# Access Compliance Report

## Public Rights-of-Way

### (Curb Ramps)

Intersection ID: N/A	Main Street: E_3RD_ST	Cross Street: S_COLLEGE_ST	Location: S
ADA ID: 1F2B0C0C046D	Ramp Type: BlendTrans1	Initial Pass/Fail: Fail	Overall Compliance: No
		Severity Score: 10

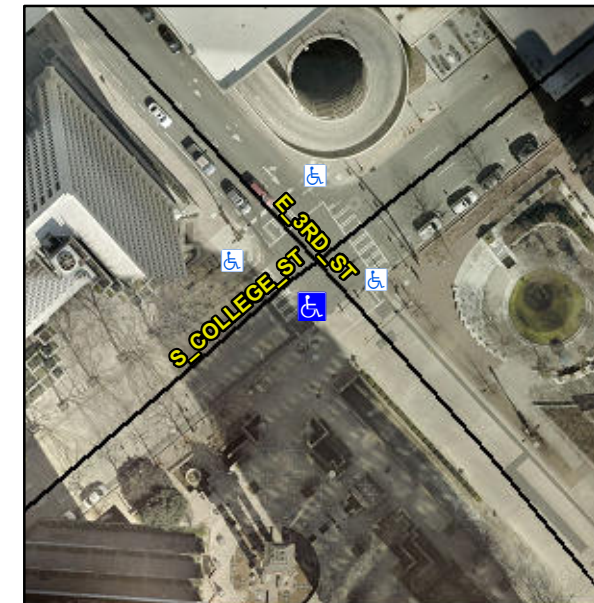
**Not Found, R304.5.1, R304.5.3, R304.4.1**

Compliance	Description	Data	Compliance	Description	Data
N/A	Ramp Length (in)	53.0	No	BlendTrans Slope (%)	7.7
No	Ramp Width (in)	45.0	No	BlendTrans XSlope (%)	4.0
N/A	Flare Type LT	N/A	N/A	Flare Type RT	N/A
N/A	Flare Slope LT (%)	N/A	N/A	Flare Slope RT (%)	N/A
N/A	Flare Traversable LT?	N/A	N/A	Flare Traversable RT?	N/A
N/A	Landing Length (in)	N/A	N/A	DWS Provided?	N/A
N/A	Landing Width (in)	N/A	N/A	DWS Contrast?	N/A
N/A	Landing Slope (%)	N/A	N/A	DWS Length (in)	N/A
N/A	Landing X Slope (%)	N/A	N/A	DWS Full Width?	N/A
N/A	Landing Curb? (Y/N)	N/A	N/A	DWS Offset (in)	N/A
N/A	Shared Landing?	N/A			
N/A	Gutter Ponding?	N/A	N/A	Gutter Slope (%)	N/A
N/A	Gutter Lip Ht (in)	N/A	N/A	Gutter X Slope (%)	N/A
N/A	Painted X Walk1?	Yes	N/A	Painted X Walk2?	Yes
	X Walk 1 Direction	To NE		X Walk 2 Direction	To NW
	X Walk 1 Width (in)	126.0		X Walk 2 Width (in)	119.0
	X Walk 1 Slope (%)	1.6		X Walk 2 Slope (%)	5.8
	X Walk 1 X Slope (%)	5.8		X Walk 2 X Slope (%)	0.8

N/A	Ramp inside XWalk1?	Yes	N/A	Ramp inside XWalk2?	Yes
	Road Slope (%)	3.5		Clear Space?	N/A
	Road X Slope (%)	8.6	N/A	Clear Space to XWalk (in)	N/A
N/A	Any Obstructions?	N/A	N/A	Storm Grate/Utility Hazard?	N/A
	Obstruction Type			Storm Grate/Utility Type	
		N/A			N/A
			Yes	Surface Condition? (G/P)	Good
			No	Curb Slope (%)	15.7

**Remove & Replace Curb Ramp With Two New Directional Ramps or Equivalent.**
